DATE: December 16, 2019

SUBJECT: ADDENDUM #4 TO THE BIDDING DOCUMENTS FOR:  
**BID GROUP #8**  
**MASTER FACILITY PLAN IMPLEMENTATION**  
**COMMUNITY HIGH SCHOOL DISTRICT 99**  
**1436 NORFOLK STREET**  
**DOWNERS GROVE, IL 60516**

This addendum forms a part of the Bidding Contract Documents, dated November 20, 2019. Bidders must acknowledge receipt of this Addendum in the space provided on the Bid Form. Drawing revisions clouded and tagged throughout with delta 41.

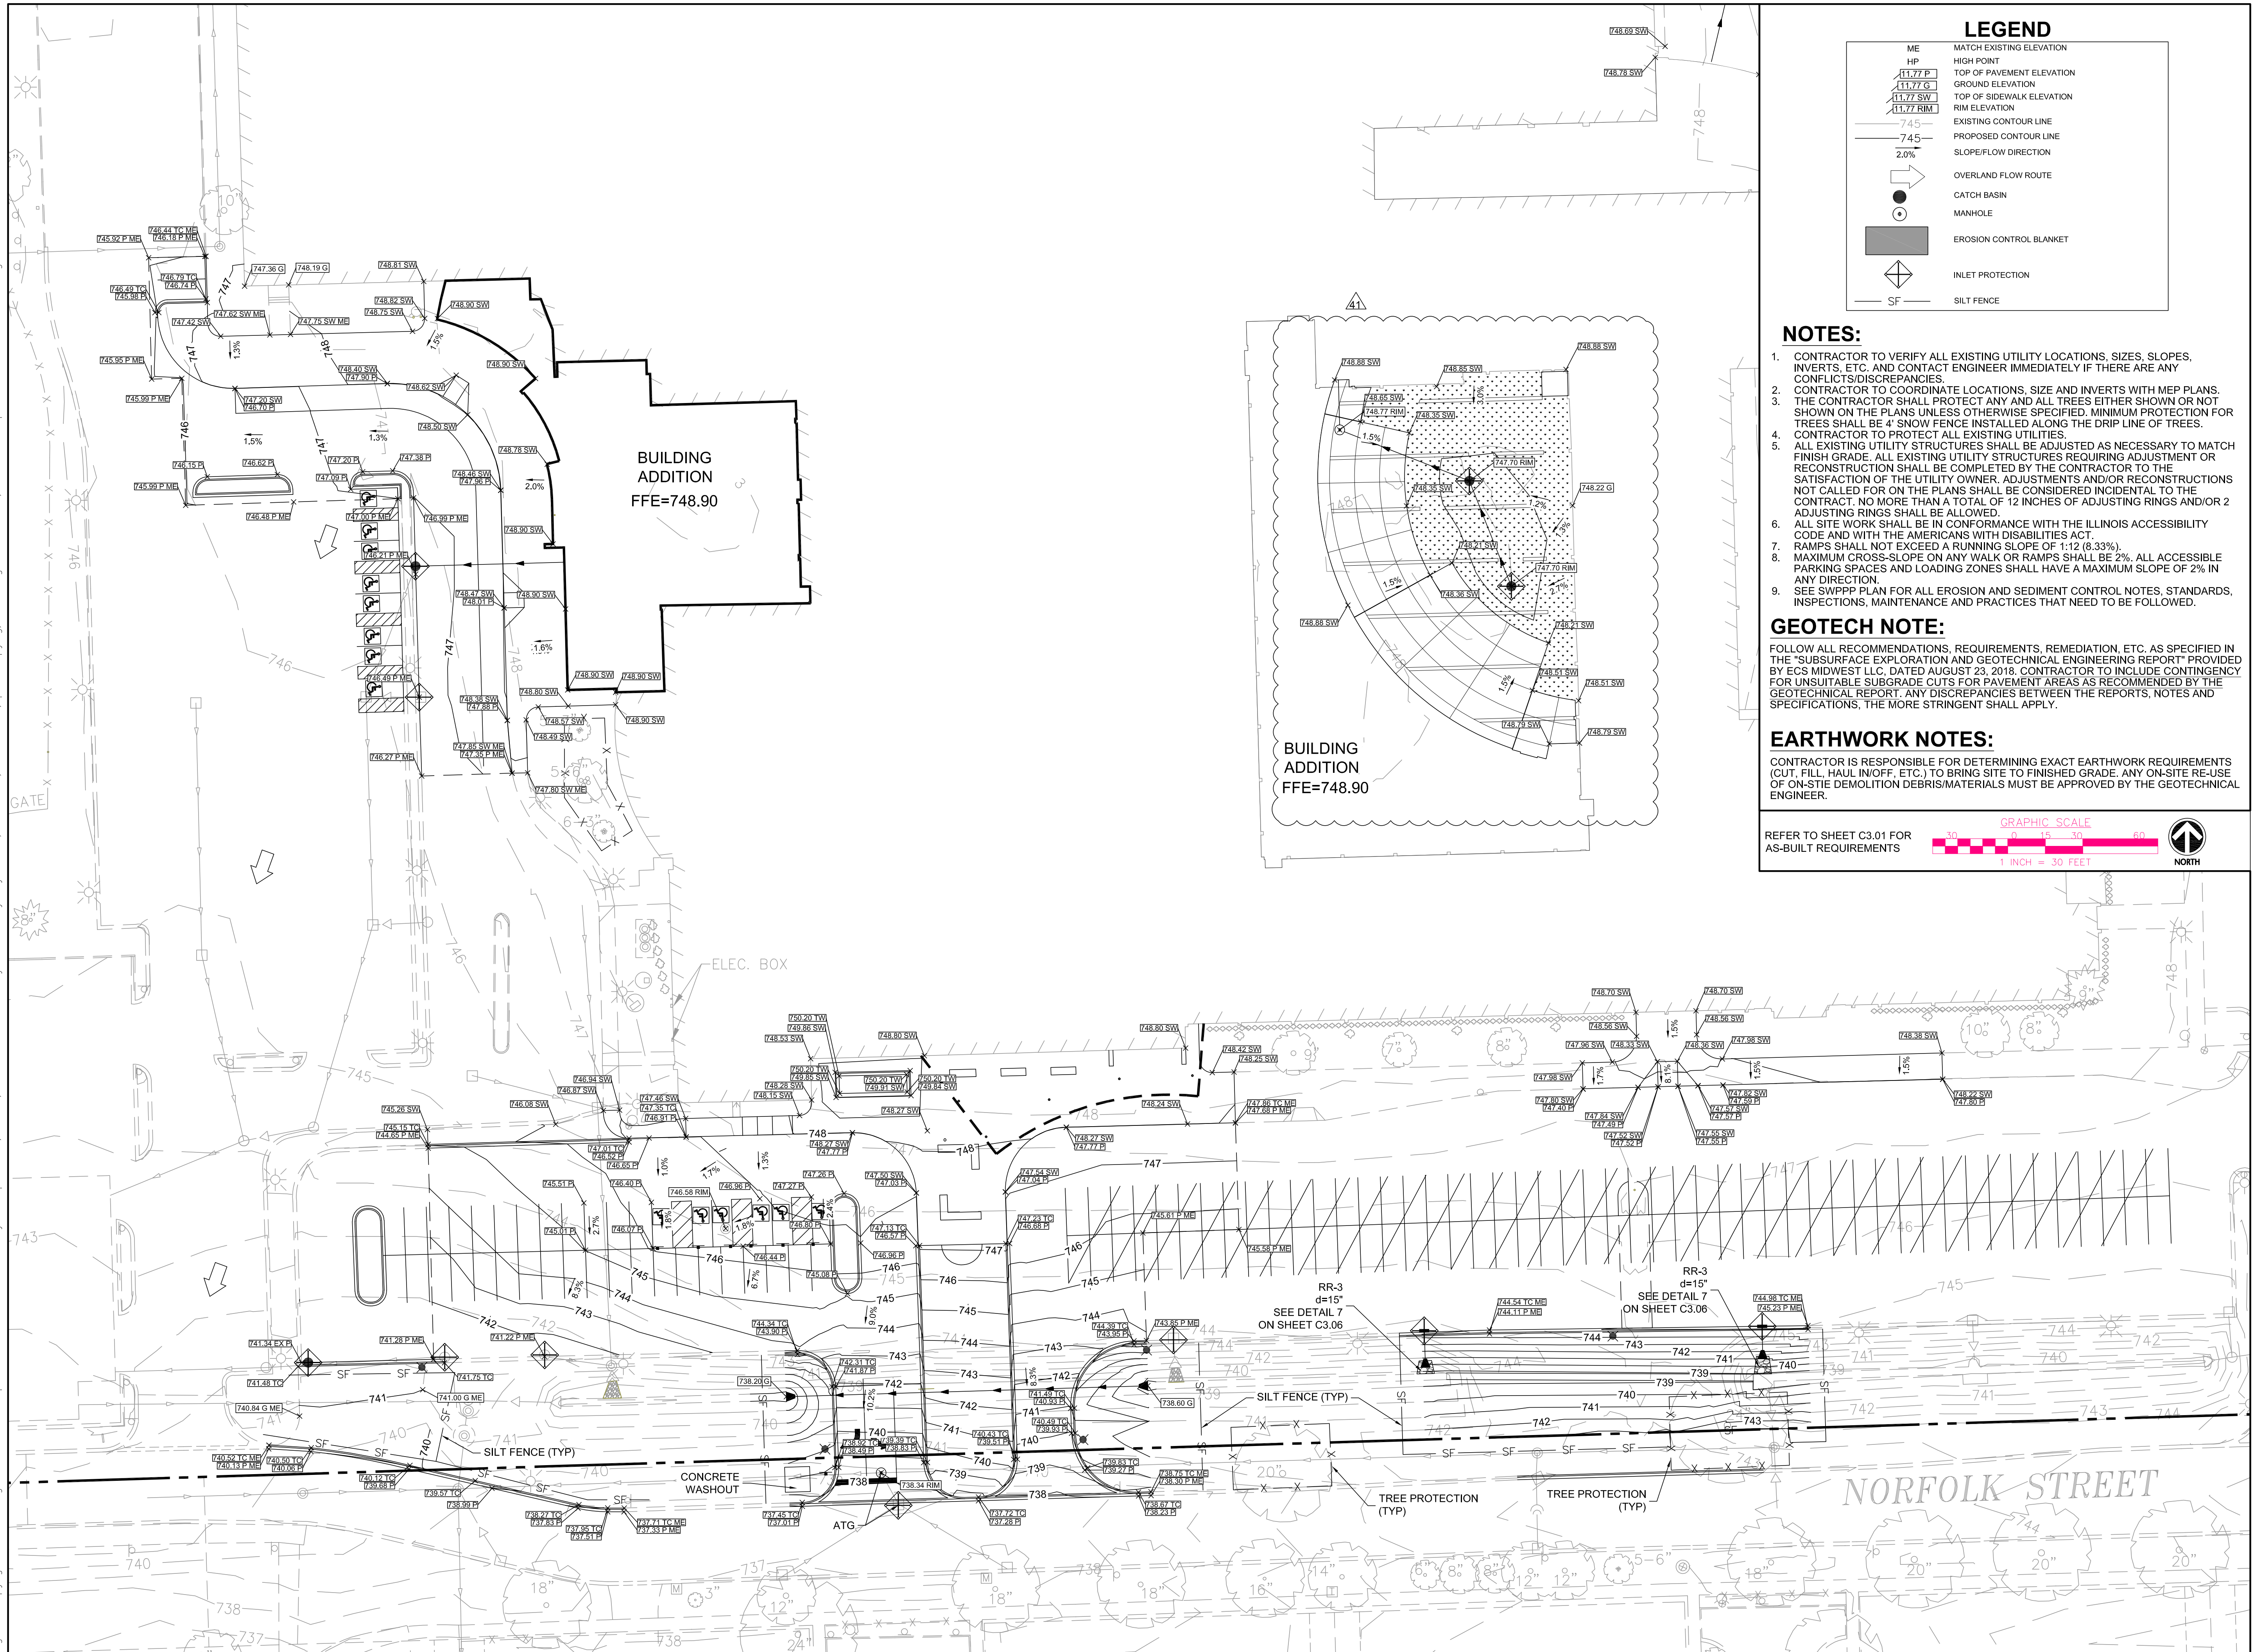
1. Sheet C3.03 GRADING AND EC PLAN SOUTH (**Full size sheet issued**)
  - a. Revised courtyard drainage to coordinate with plumbing.
2. Sheet C4.03 UTILITY PLAN SOUTH (**Full size sheet issued**)
  - a. Revised courtyard drainage to coordinate with plumbing.
3. Sheet C4.06 UTILITY PROFILES SOUTH (**Full size sheet issued**)

1 AREA F - LEVEL 1 ENLARGED FOUNDATION PLAN  
SCALE: 1/4" = 1'-0"

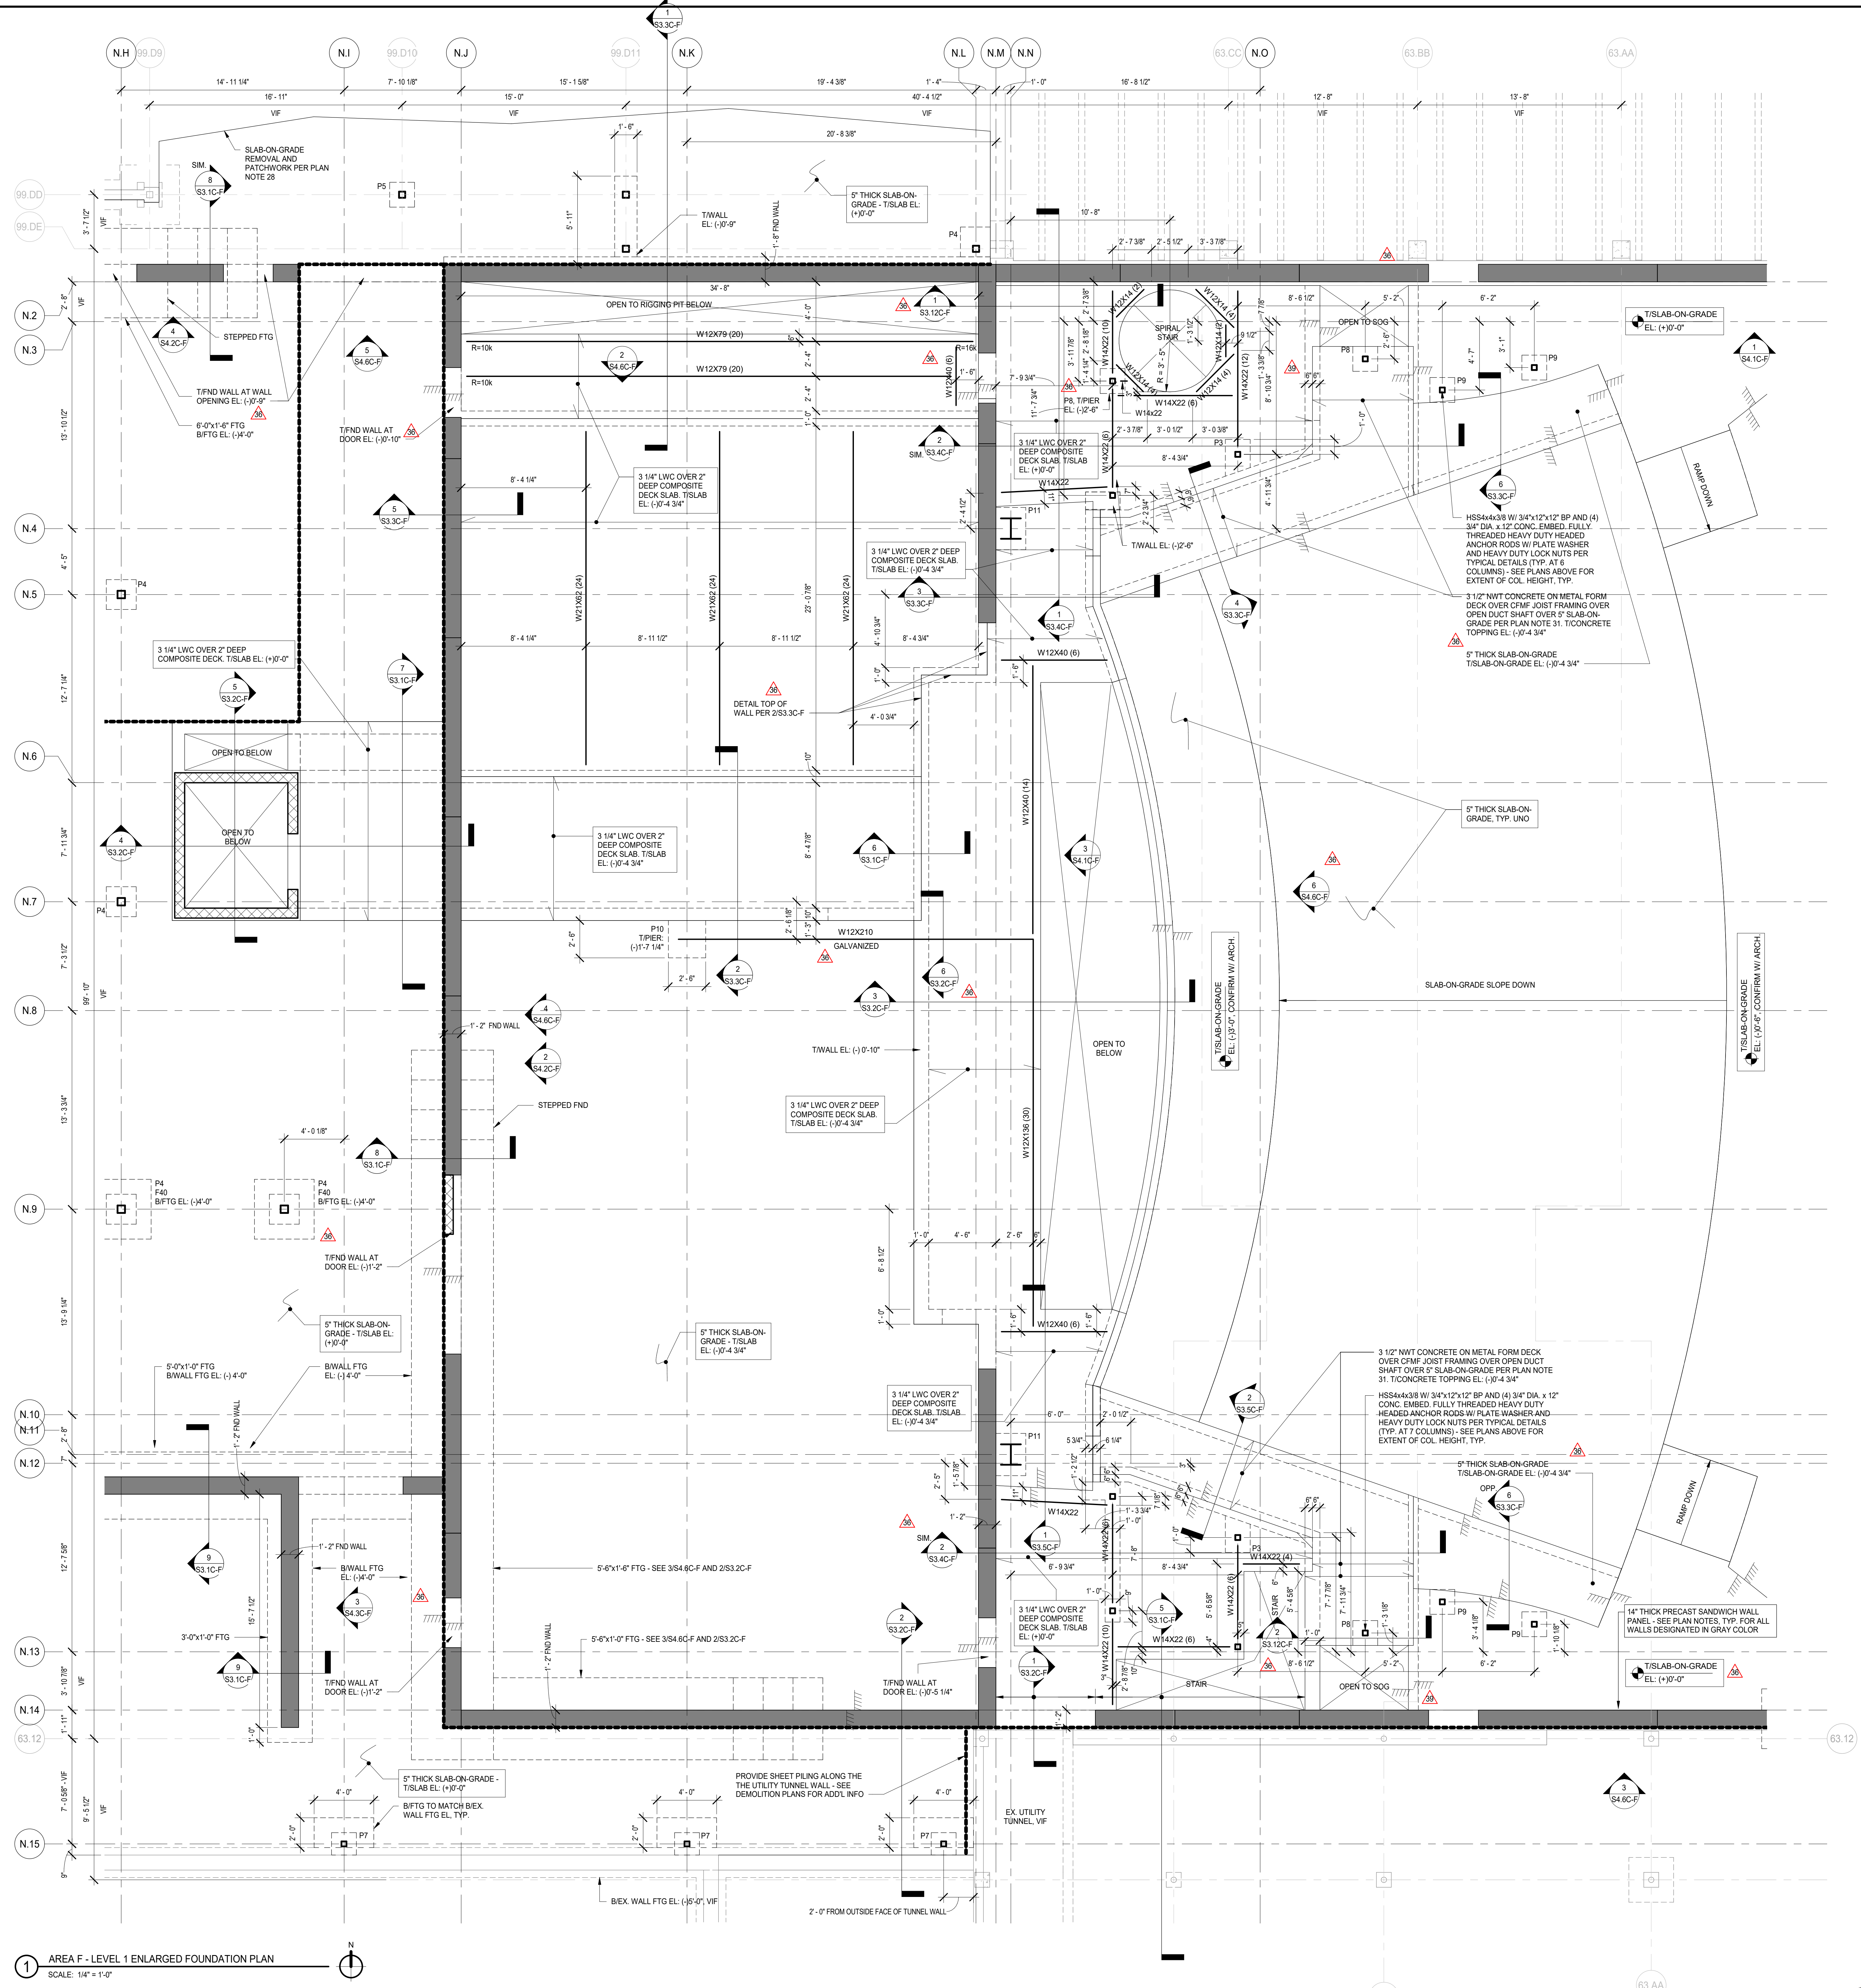
- b. Added masonry wall infill per new plan note 38 at one location.
6. Sheet S2.1C-F-EP1 ENLARGED FOUNDATION PLANS (**Full size sheet issued**)
  - a. Plan 2: Added wind brace column for decorative column cover.

2 AREA F - FLY GALLERY ROOF FRAMING PLAN  
SCALE: 1/8" = 1'-0"

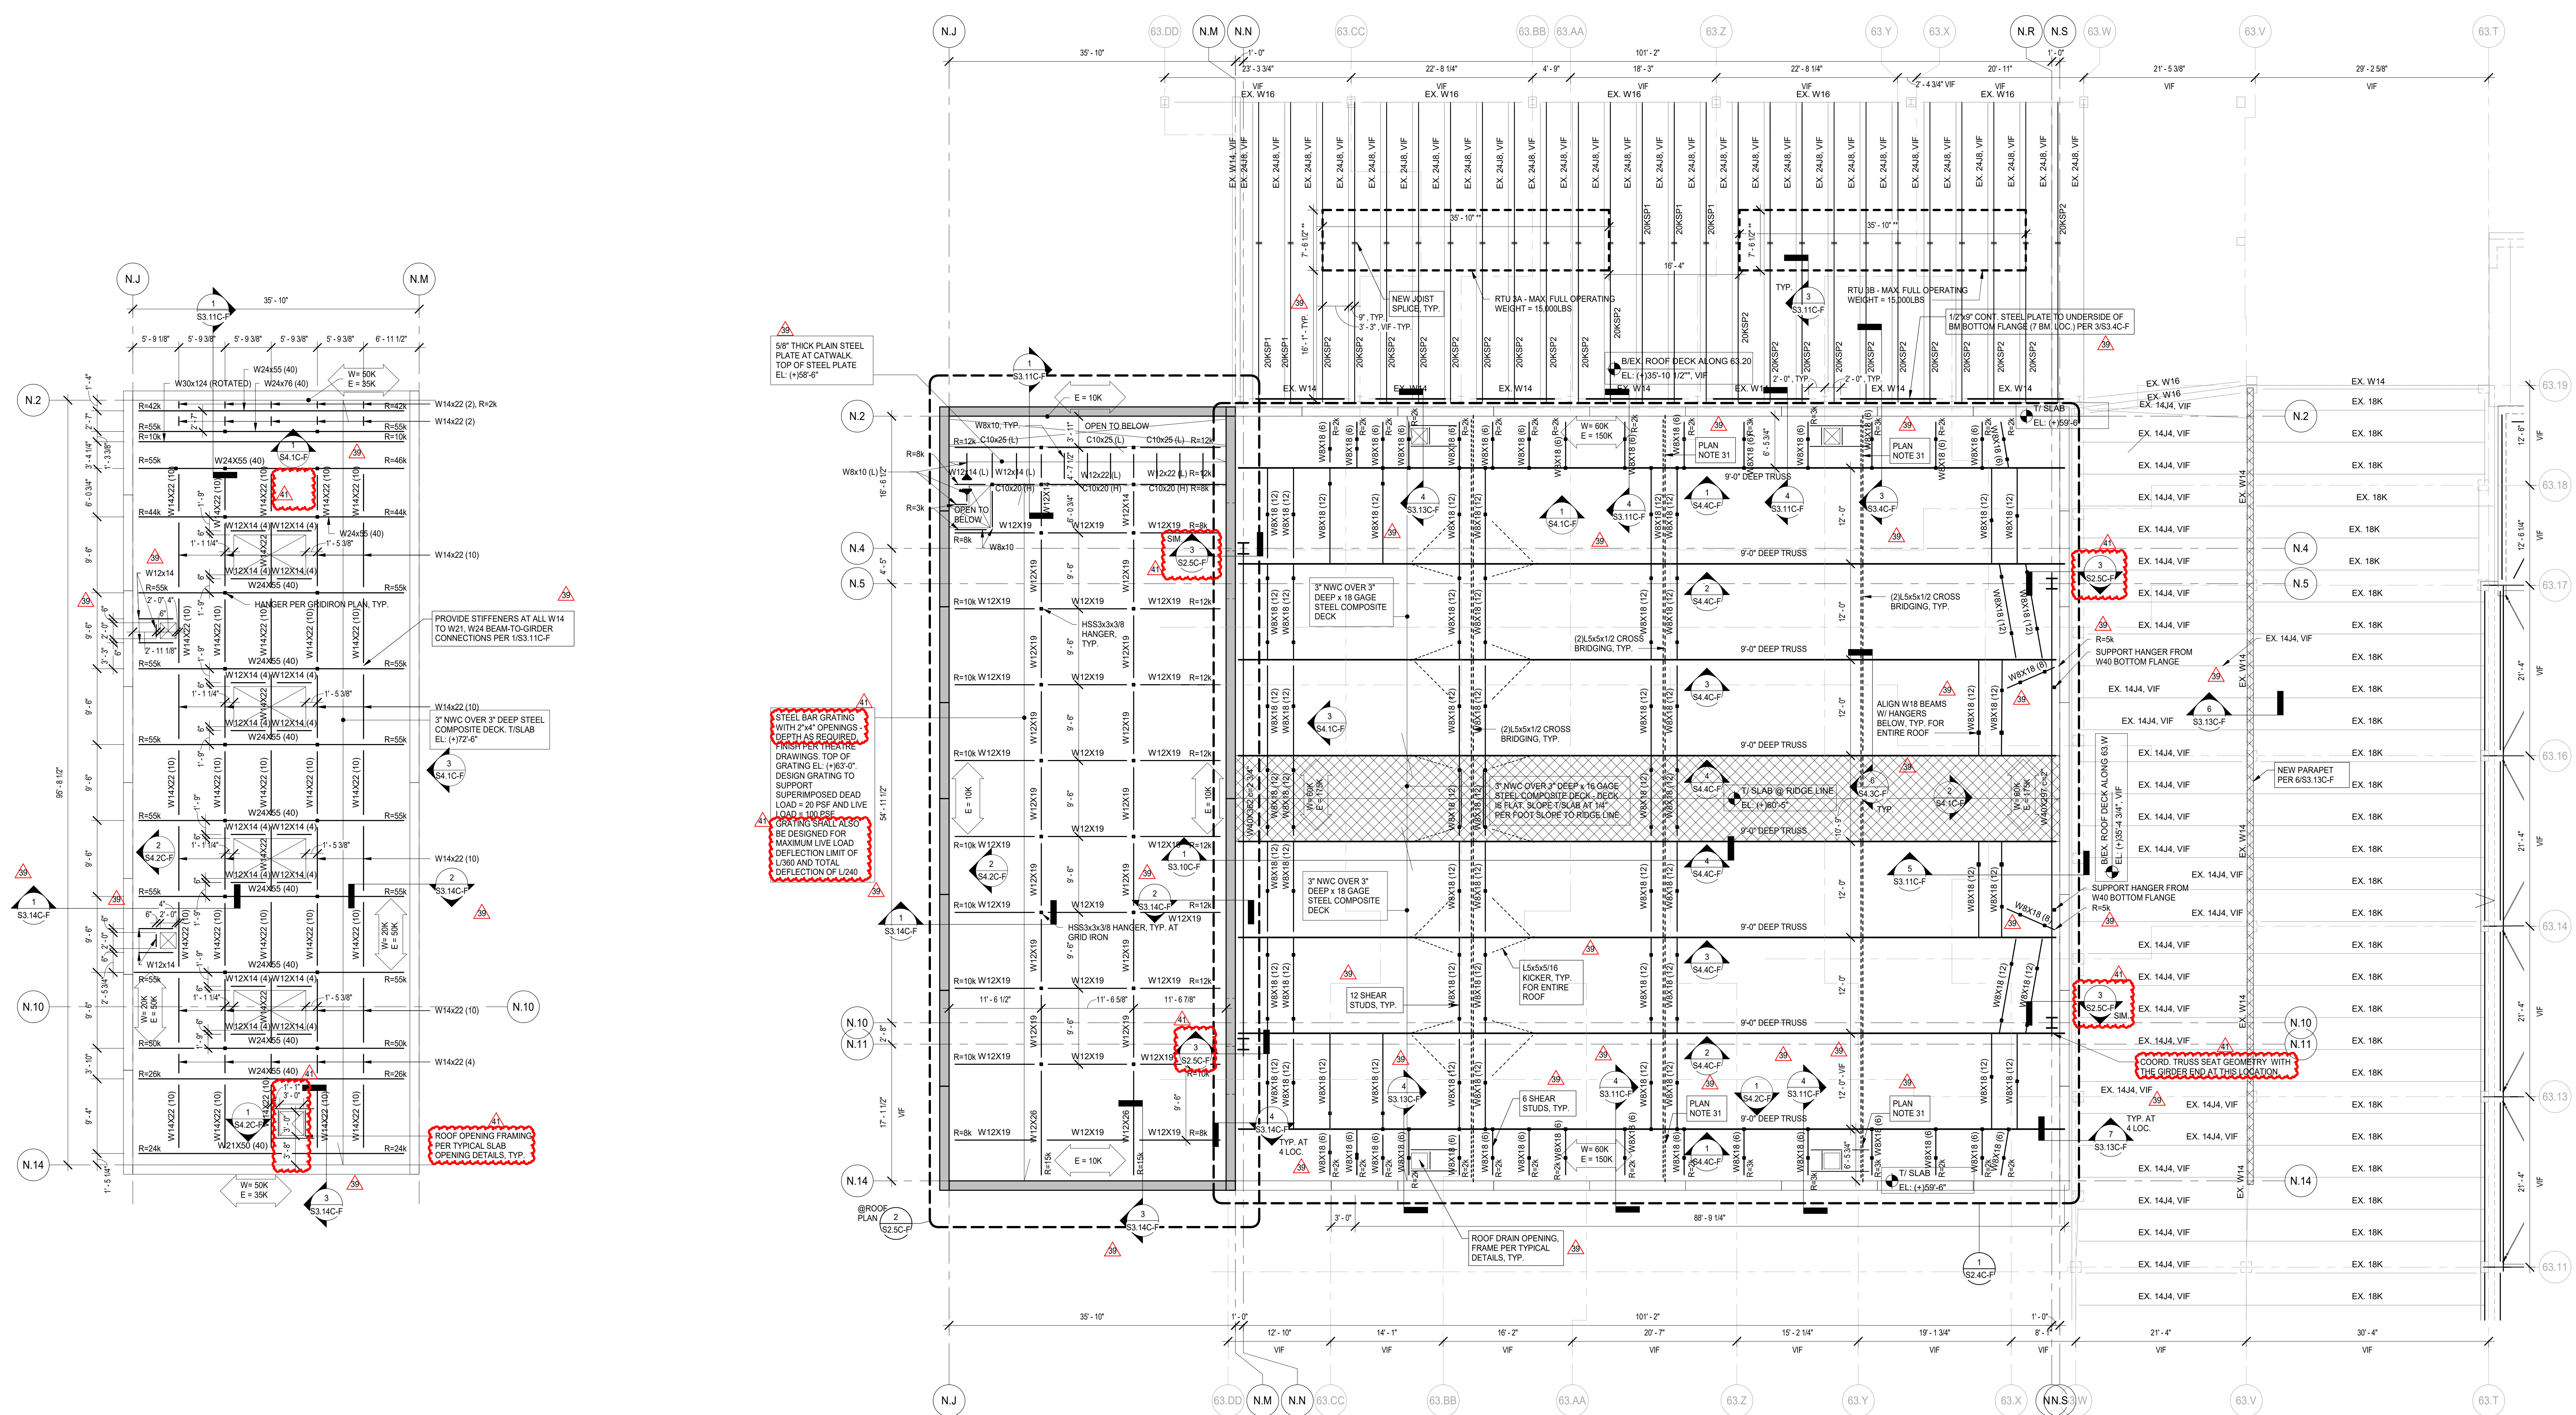
- b. Plan 2: Relocated the roof hatch opening.
10. Sheet S2.6C-F ENLARGED PLANS (**Full size sheet issued**)
  - a. Plan 7: Added steel support for the spiral stair and revised existing beam end reactions at precast wall accordingly.
